PoDI / NHS	
PROJECT OF DIVISION INTEREST (PoDI)?	<input checked="" type="checkbox"/> NO <input type="checkbox"/> YES
NATIONAL HIGHWAY SYSTEM?	<input checked="" type="checkbox"/> NO <input type="checkbox"/> YES

DEPARTMENT OF TRANSPORTATION STATE OF COLORADO

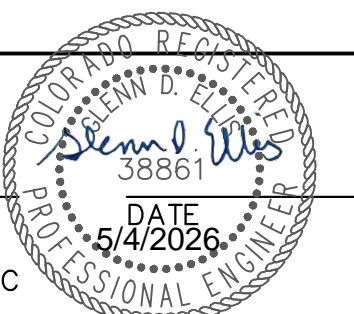
Print Date: 04/13/2026	Sheet Revisions			Colorado Department of Transportation	As Constructed	LEWIS PALMER TRAIL-BRIDGE		Project No./Code
File Name:	Date:	Comments:	Init.	of Transportation	No Revisions:	COVER SHEET		M915-009/22585
Horiz. Scale: N/A					Revised:	Designer: GG	Structure Numbers	2520300
Unit name						Void:	Detailer: GG	Subset Sheets: OF
						5615 WILL BLVD. Pueblo, CO 81008 Phone: 719-546-5750	5615 WILLS BOULEVARD PUEBLO, CO 81008 CONTACT: JUNIOR RODRIGUEZ P~(719) 251-6980
